September 20, 2022

**Re: Proposed 40B: Residences at Park Central**  
**Project Eligibility/Site Approval Application**

Kathryn M. Cook, Chair  
Southborough Select Board

**Exhibit 2- Overview of Flagg Road Danger**

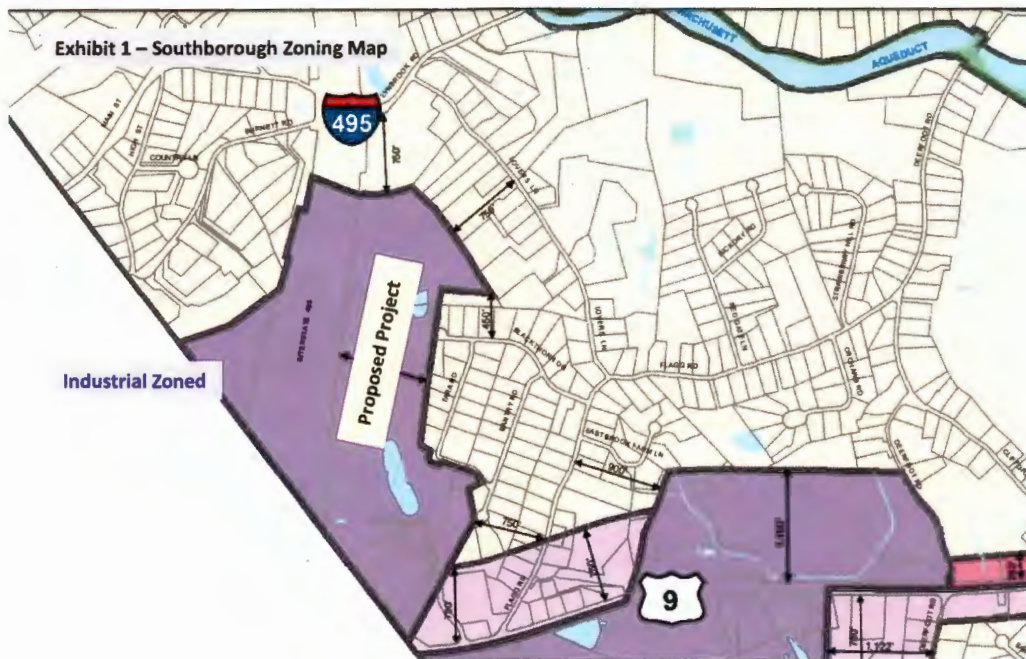
- E. Flagg Road Truck Exclusion: Flagg Road already has a truck exclusion for the same reason: safety concerns regarding accidents and pedestrian safety.
- F. Southborough Scenic Road: The age of the road and its prominent stone walls and older trees spurred Southborough to declare Flagg Road a scenic road<sup>34</sup>
  - a. The builder's proposal notes that Flagg is a "gently winding road," which overlooks the presence of sharp curves and several points of zero visibility.
